EXPERT-PANEL REVIEW OF CNWRA VOLCANISM RESEARCH PROGRAMS

**Center for Nuclear Waste Regulatory Analyses
San Antonio, Texas**

**January 1995
Revised March 1995**

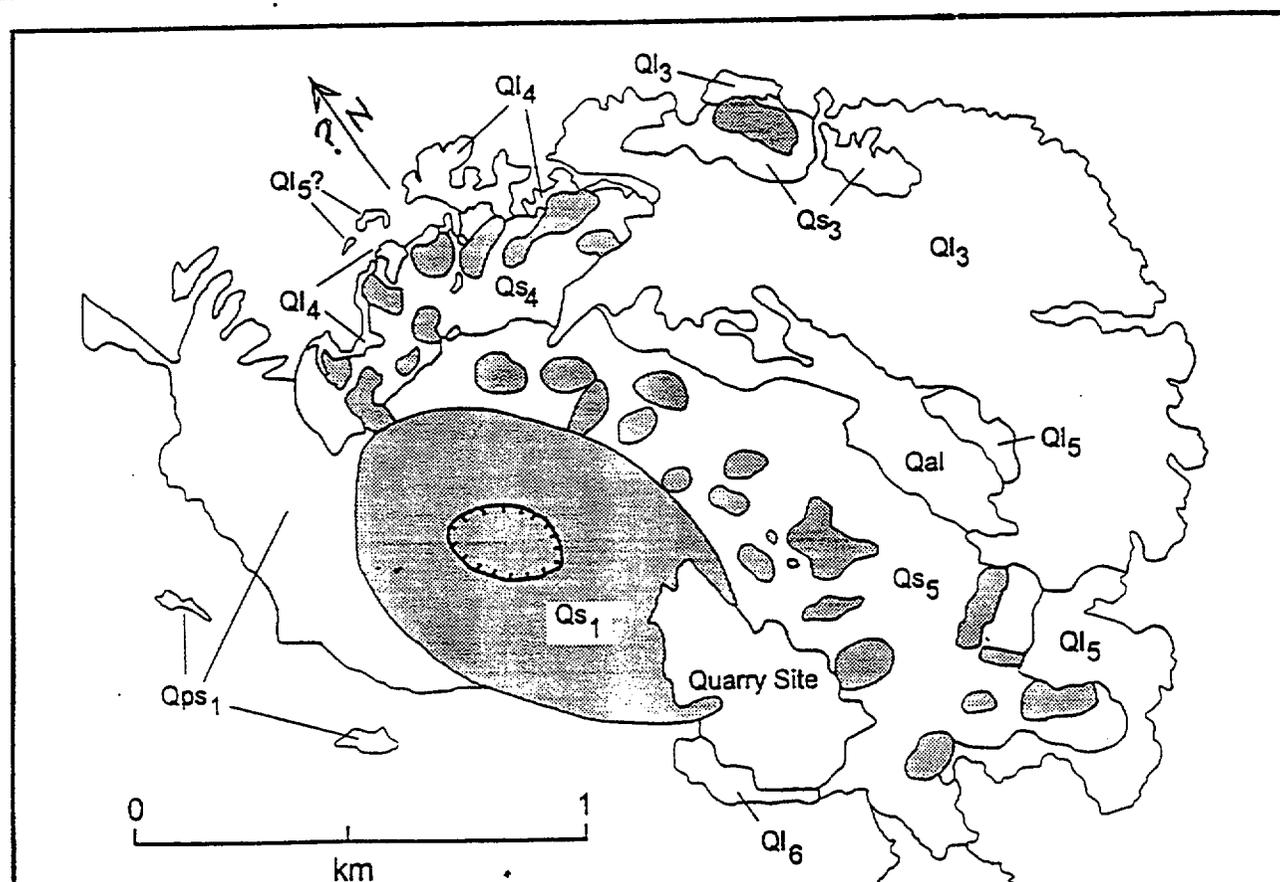
According to some published accounts, Lathrop Wells volcano is "polycyclic" (i.e. polygenetic: built by two or more eruptions). This conclusion appears to depend on the interpretation of scoria mounds found around the foot of the main cone as small cones situated at multiple primary vents. According to this interpretation, rough alignments of these mounds would reflect primary eruptive fissures, three of which (in addition to the fissure presumed to underlie the main cone) would then be required to account for all of the mounds. Also, cinder cone and lava flows have been interpreted to form during separate eruptions.

This published map of Lathrop Wells volcano shows numerous small stippled areas representing small scoria mounds outside of the main cone. I have seen an interpretation in which these mounds mark multiple vents developed on several fissures additional to the main vent. A much simpler interpretation is that the mounds are scoria rafts carried laterally on lava flows. I have watched such rafts forming. Ashy material at one of the small areas labelled Qps is interpreted as pyroclastic surge deposits. I was unimpressed by this interpretation.
